**BTRE
FOUR SPEED ELECTRONIC
AUTOMATIC TRANSMISSION
DEALER TRAINING SEMINAR
REVISION IV**

AUGUST 1994

Transmission Plant – Albury

FIGURE 2: LINE RELIEF VALVE ASSEMBLY.

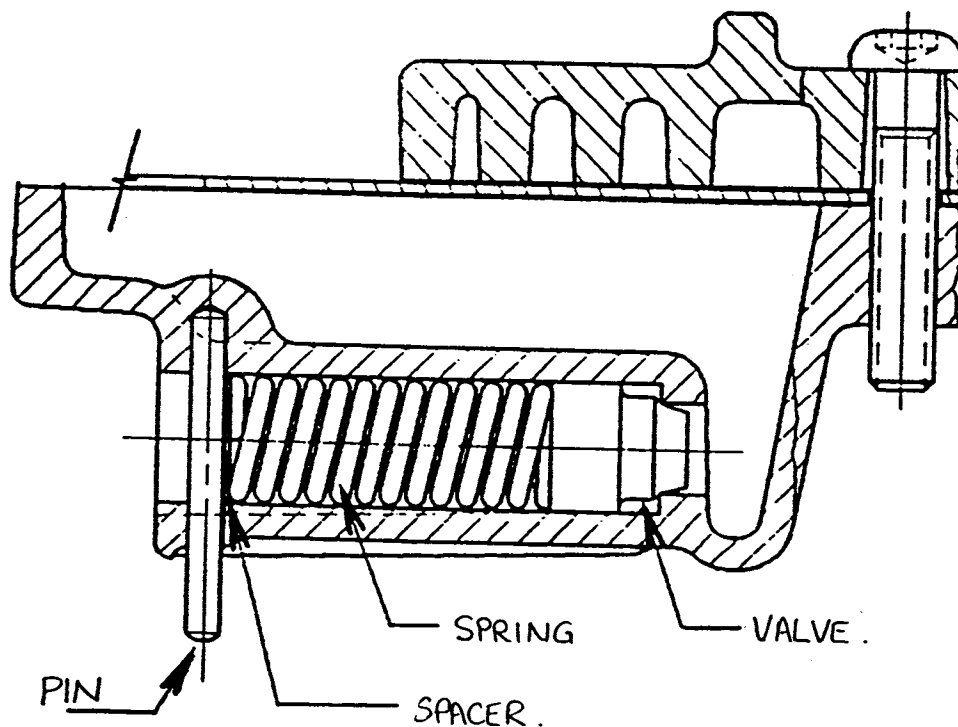
Transmissions with serial numbers above 55289 (T-Bar) and 35654 (Column Shift), are assembled with line relief springs with non-ground ends (Part Number 0585-156143). This change is made to prevent valve buzz and also to increase reverse gear high line pressure.

- a) Remove pan and filter from transmission, do not remove valve body.
- b) Precompress line relief spring using a screw driver or similar tool and remove retainer pin.
- c) Remove spacer (if fitted), line relief spring and line relief valve. While the components are disassembled, check that the valve moves freely in the bore.
- d) Install valve, new spring 0585-156143 (non-ground ends), 0.3mm thick spacer and retainer pin. Refer figure 2.

FIGURE 3: CAF HOLE AND 33° CHAMFER.

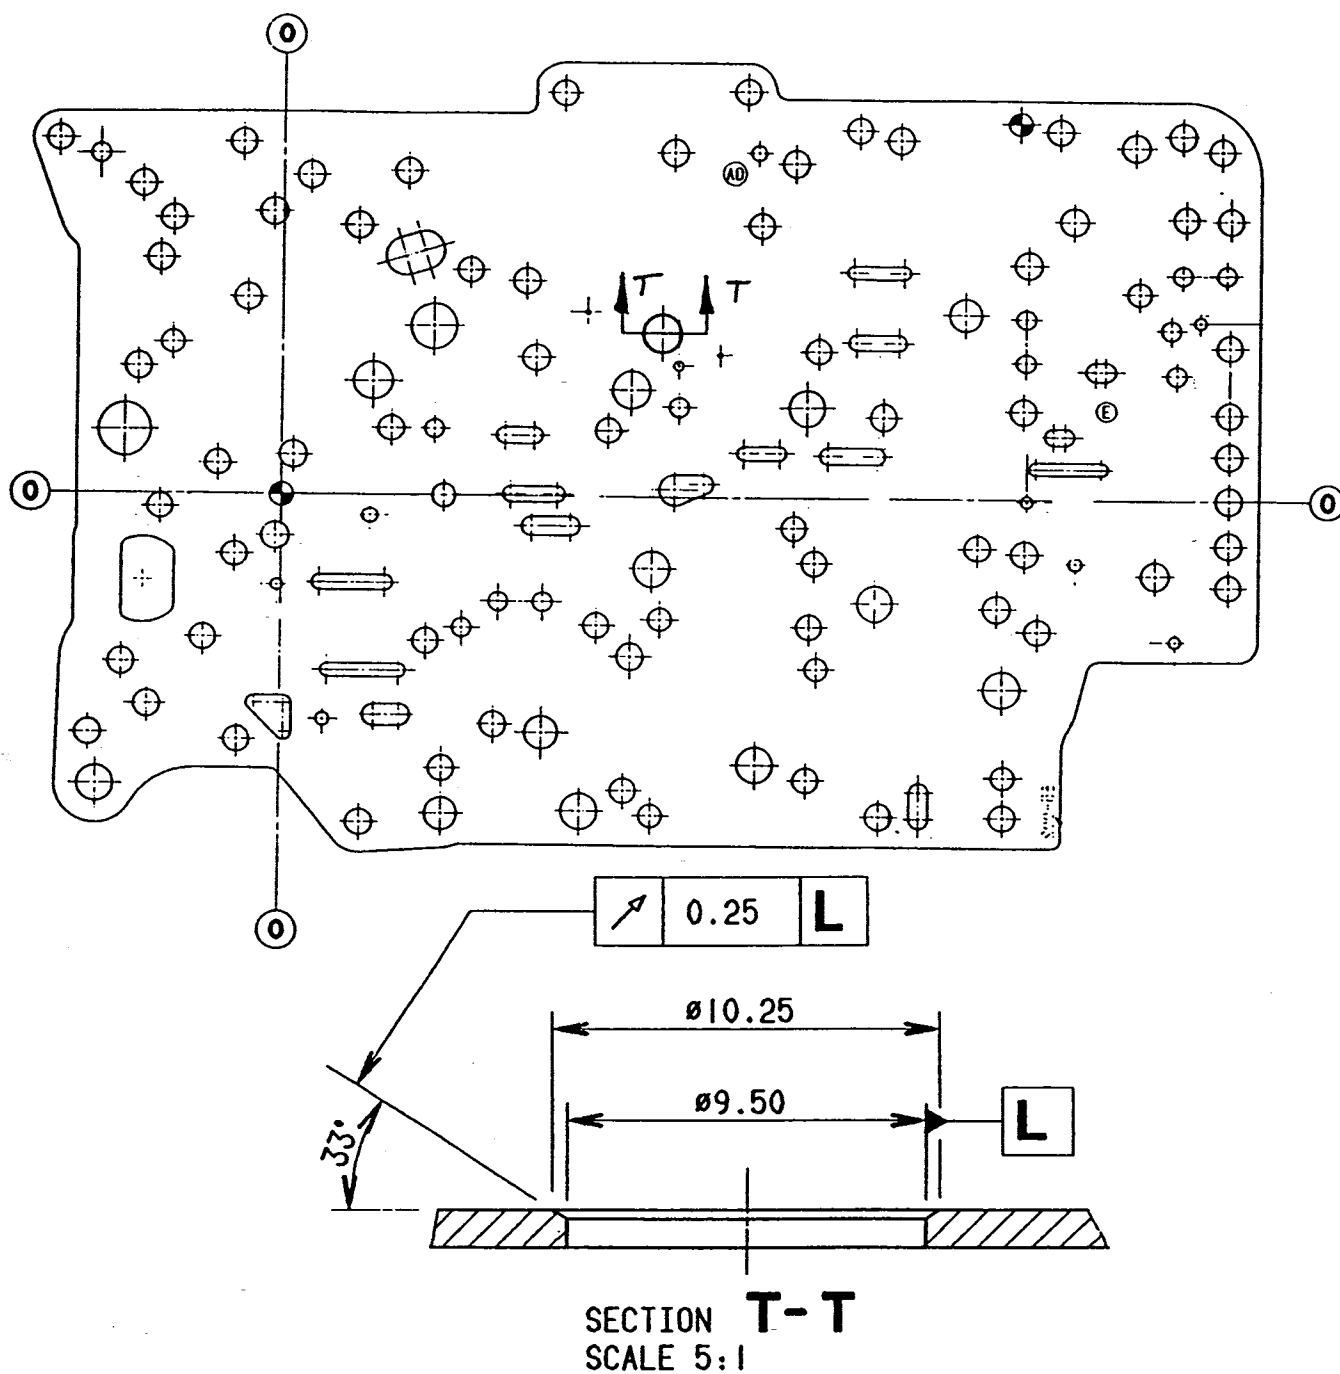
M85 Transmissions built after the 15th of January, 1990 are assembled with baffle plates having a 33° chamfer on the Ø9.5 CAF hole. Refer Figure 4. This change provides a smooth deburred surface for the ball to seat against, thus preventing wear of the ball.

- i) Replace the CAF ball with a new one if it shows any signs of wear i.e. surface is rough and/or diameter is less than 11.5mm.
- ii) Inspect the CAF hole in the baffle plate. If the hole does not look like the one shown in Figure 3, or the hole edge quality is not smooth and deburred, replace the baffle plate with a new level component. (BTRE Part Number 0585-036002).

FIGURE 1: TORQUE CONVERTER UN-LOCK
FIX COMPONENTS.

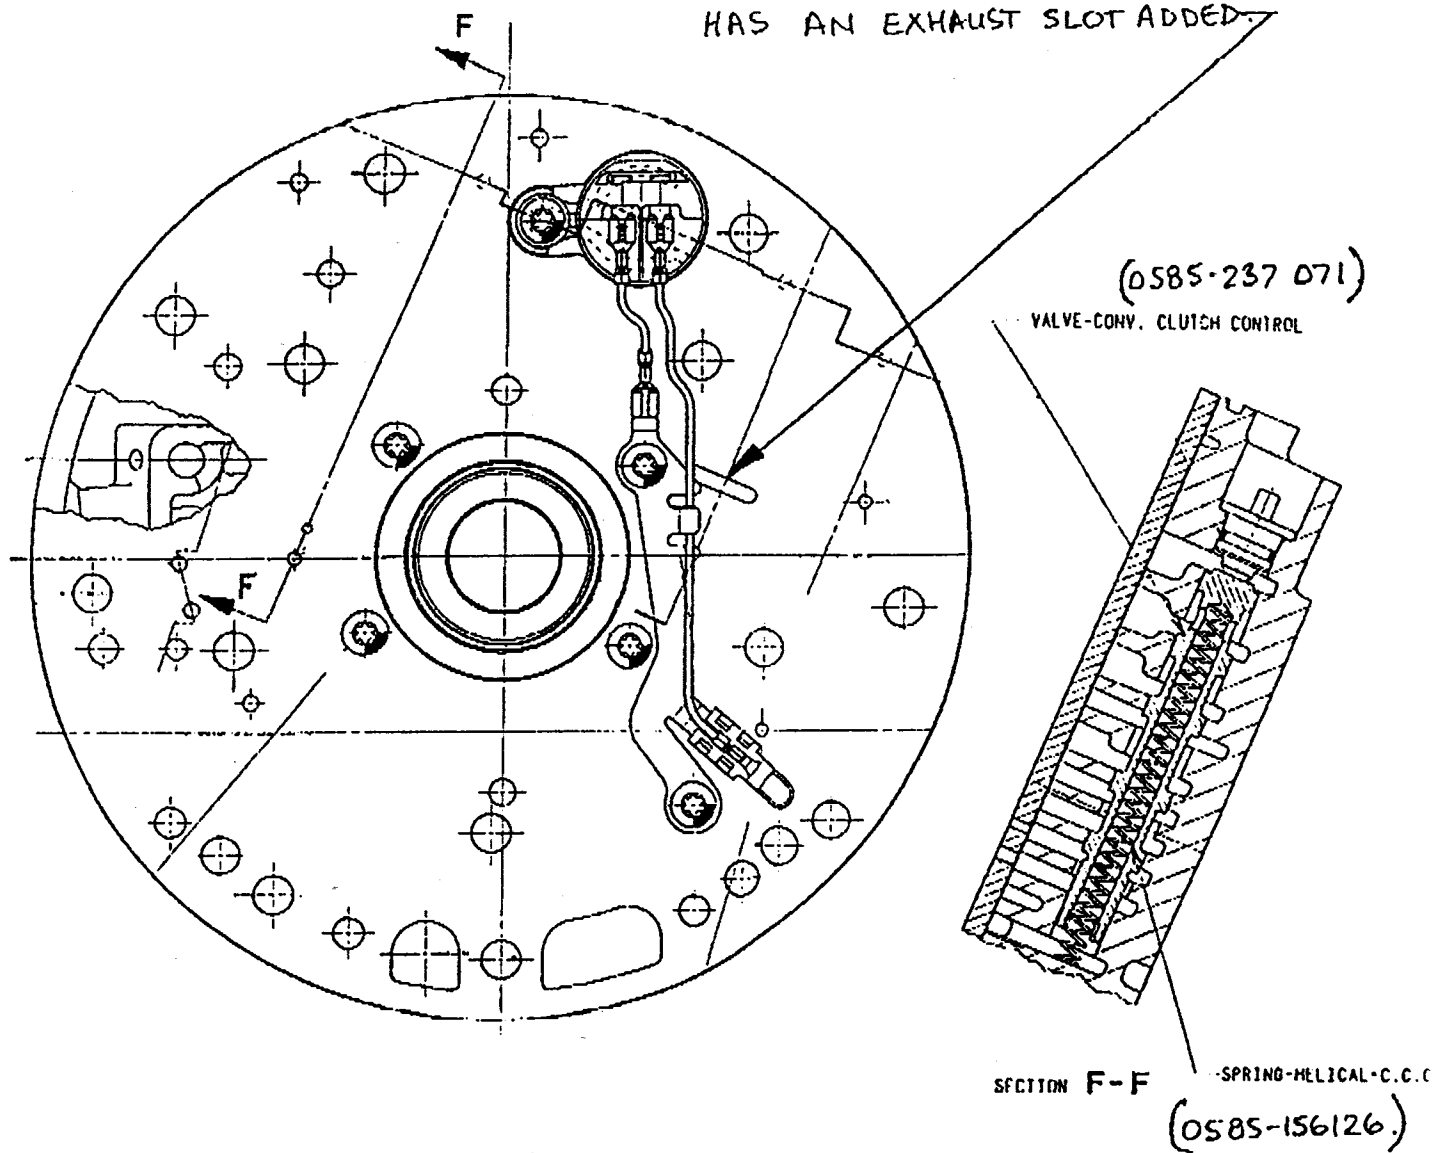
NEW COVER PLATE 0585-014029
HAS AN EXHAUST SLOT ADDED.

- i) Ensure that the pump cover is fitted with the latest level converter clutch control valve 0585-237071 and spring 0585-156126. Refer Service Bulletin 211. These parts will ensure that the torque converter does not drain down when left standing for long periods.
- ii) Replace pump cover plate with new plate 0585-014029 and use a new gasket (0585-045018). Refer Figure 1.

SOLENOID S7 IN PUMP COVER ASSEMBLY
FIGURE 1

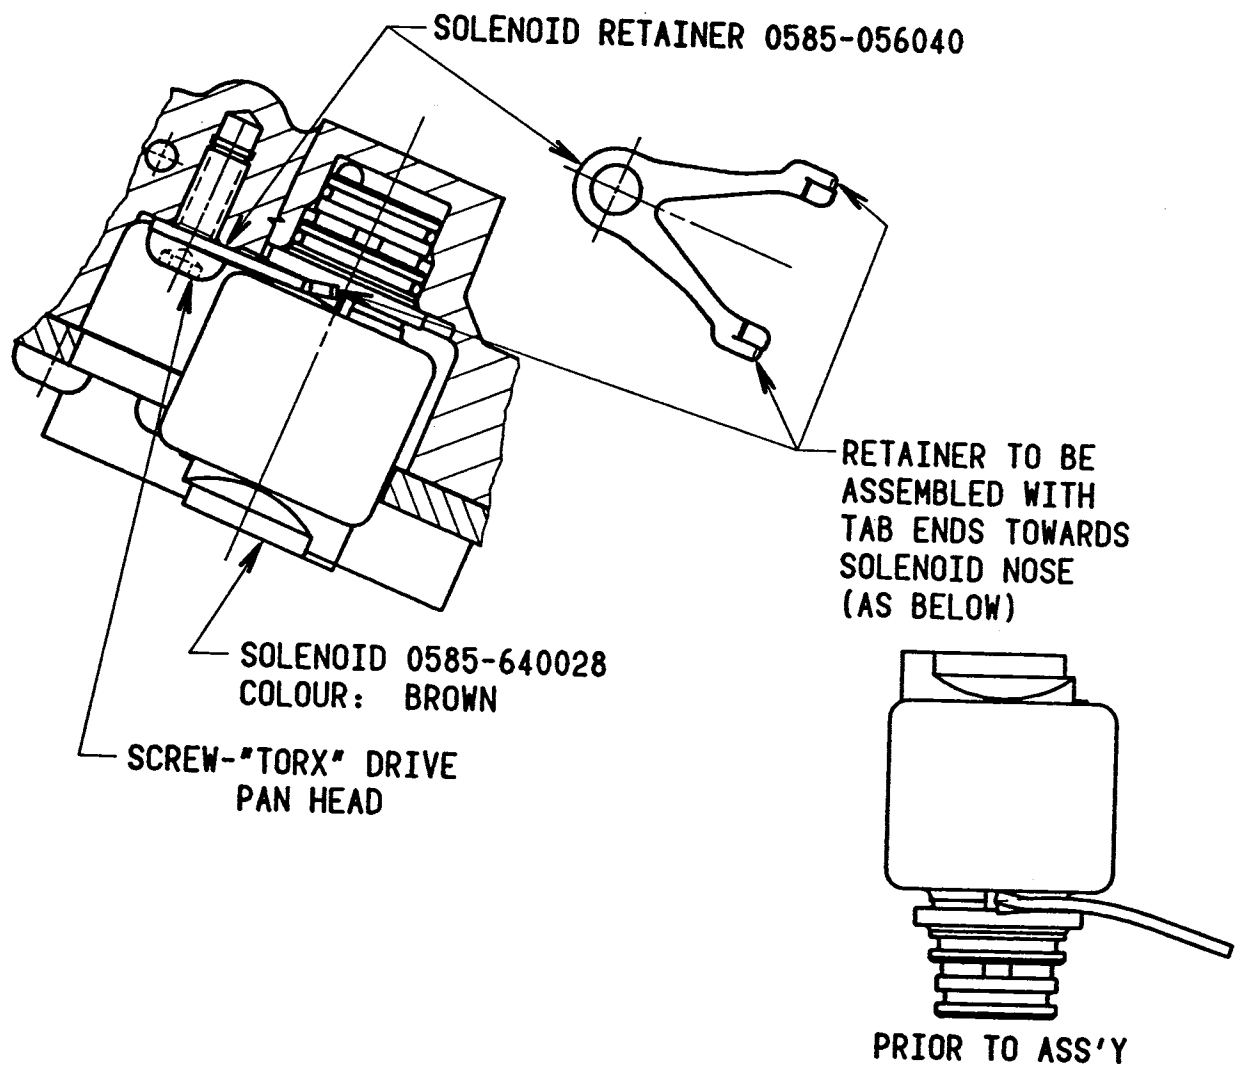
The pump and cover assembly has been modified to use a moulded normally closed (NC) solenoid in the S7 position. See Figure 1.

Figure 1. New gasket 0591-045047

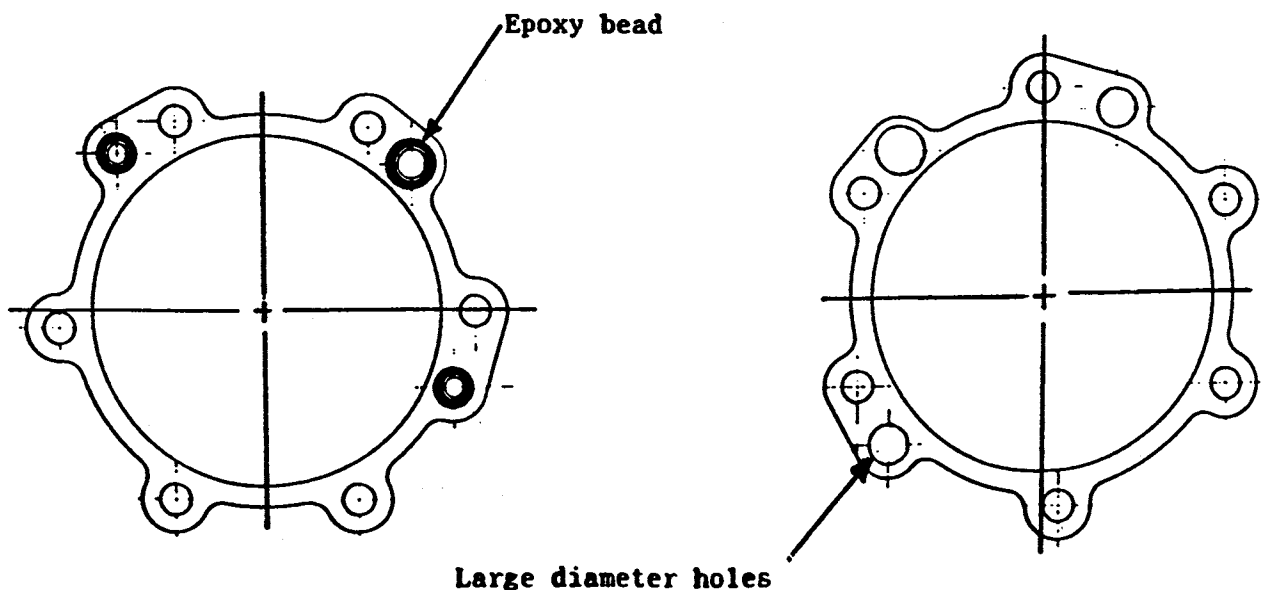
The new gasket can easily be distinguished from the previous gasket, in that the new gasket, (Figure 1.) is 0.8mm thick and has circular epoxy beads printed around the pressure ports where the three o-rings were previously located. The previous gasket, as shown in Figure 2. is only 0.35mm thick.

Figure 3. New cover 0591-539025

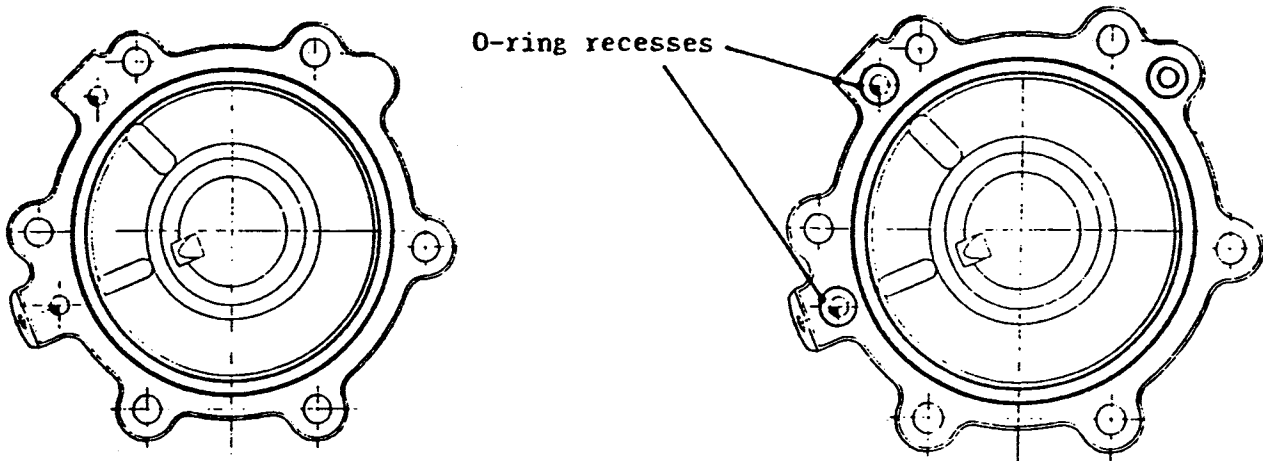
This new Rear Servo Cover, (Fig. 3), can be identified by the deletion of the three O-ring recesses in the mating face of the cover. Figure 4 below shows the previous Rear Servo Cover (Part No. 0585-539009).

FIGURE 2: RETAINER (SEAT - SPRING)

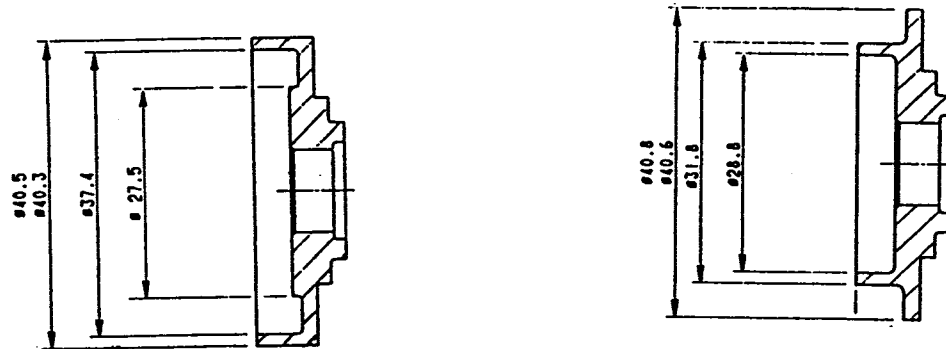
NEW DESIGN Dwg No 0593-040040

- c) For the new design return spring and retainer, a retaining screw and washer do not have to be fitted and it is recommended that these parts be removed when the new retainer and spring are installed.

FIGURE #2, TRANSMISSION CASE,
WITH INTERNAL LUBE DRILLING.

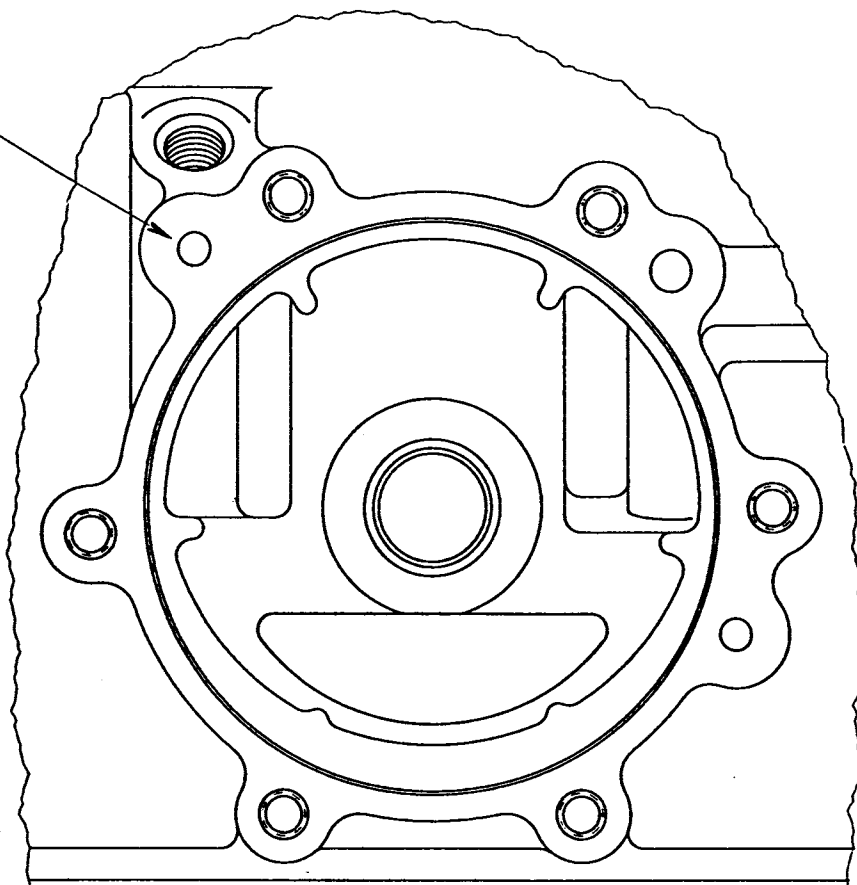
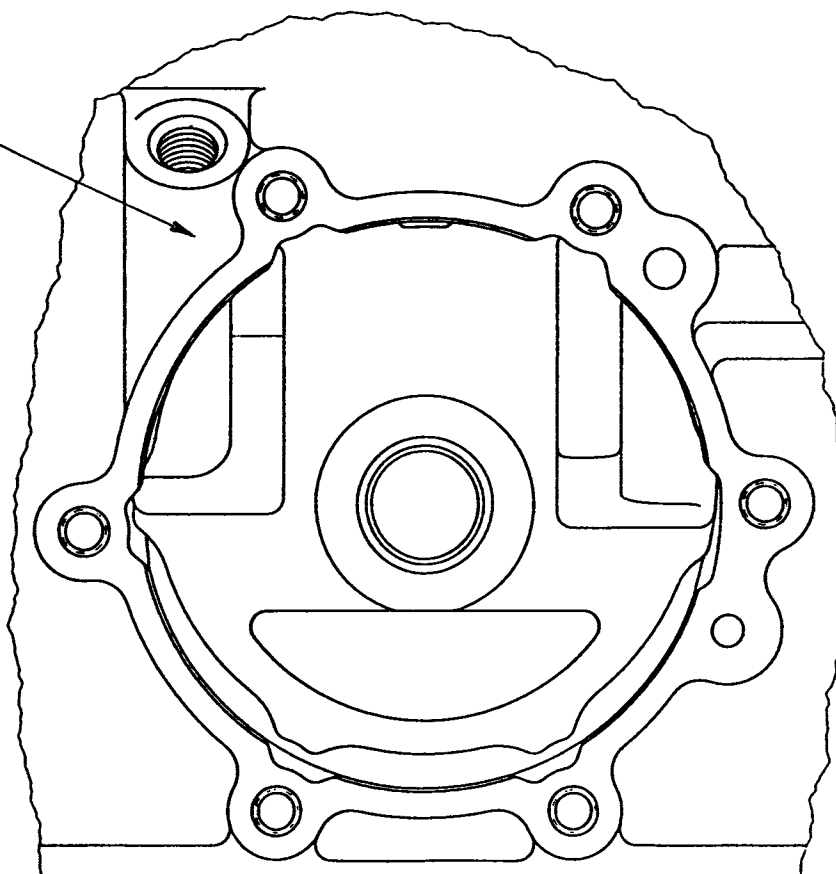
The transmission case was modified in March 1993 to allow the lube hole drilling to be relocated from an external point to an internal one Refer figures #1 and #2.

Figure 2 : Detail of new gear design changes together with a comparison of the former gear design

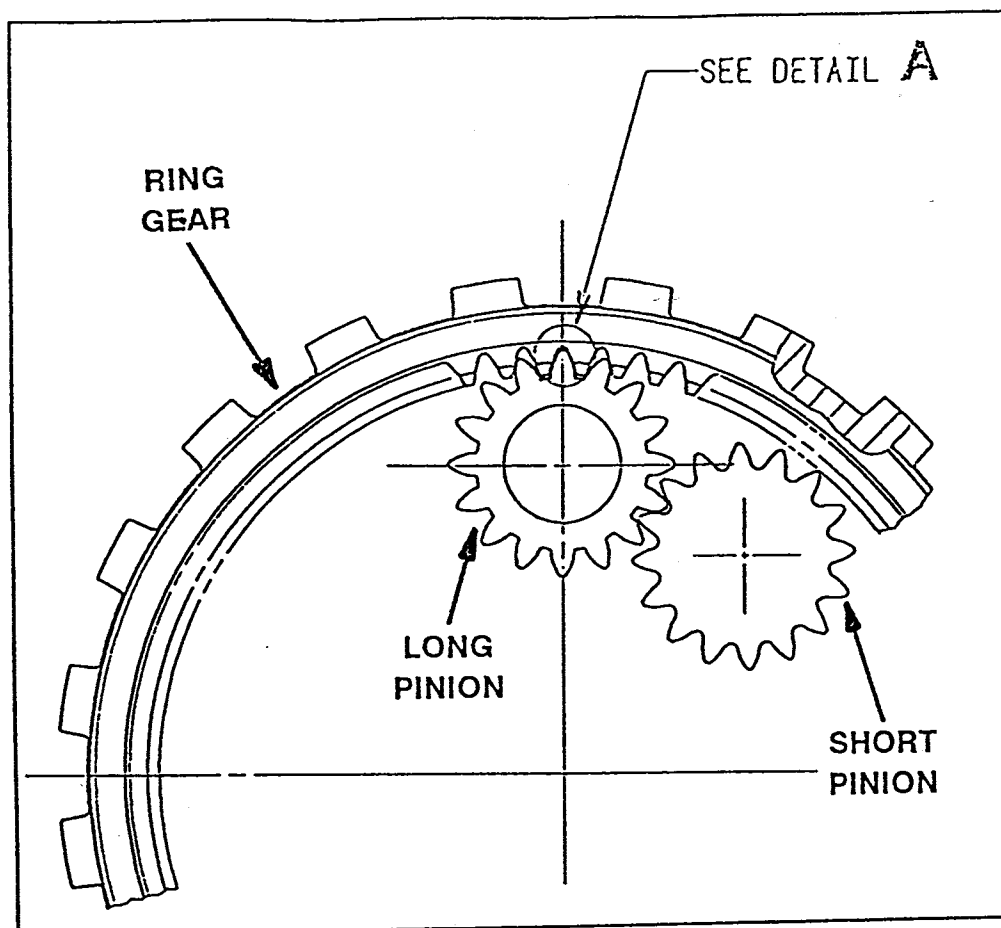
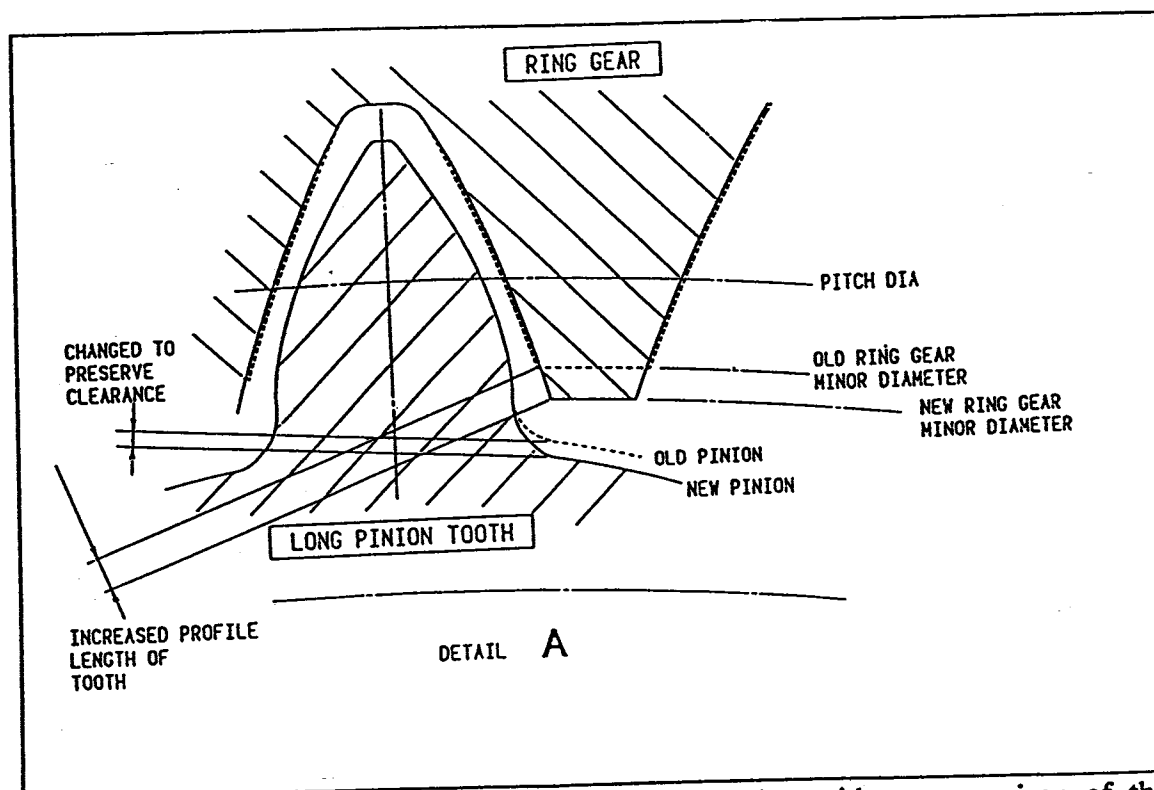
A new improved gear set design has been introduced to BTRE four speed automatic transmissions. This new gear set increases the contact ratio between the long planet pinion and the ring gear. For a sketch detailing this change refer to Figures 1 and 2 of this service bulletin.
